Central Valley Regional Water Quality Control Board

ORDER AMENDING CLEAN WATER ACT SECTION 401 WATER QUALITY CERTIFICATION AND ORDER; CALIFORNIA DEPARTMENT OF TRANSPORTATION, DIBBLE CREEK CAPM PROJECT EA 02-4H020 (WDID NO. 5A52CR00228A1), TEHAMA COUNTY

AMENDMENT:

Attachment AUpdated Figure 2: Project Impacts Map EA 02-4H020

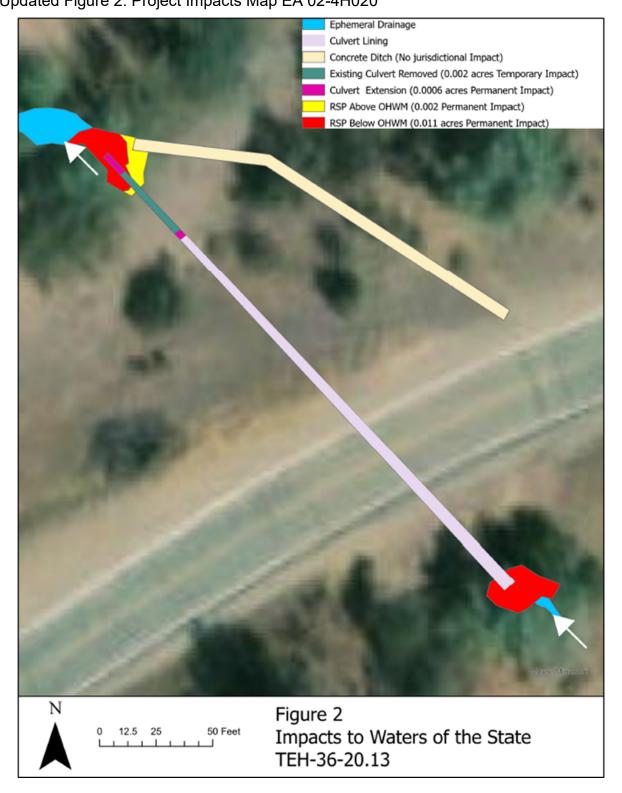
California Department of Transportation is requesting an amendment to the Section 401 Water Quality Certification and Order for an increase in permanent impacts to waters of the state and a change in the compensatory mitigation requirements. Therefore, Section IV; Section VII, Table 2; Section XIV.K.3; Section XIV, Table 4; Attachment A, Figure 2; and Attachment B, Table 3 are amended in underline format below.
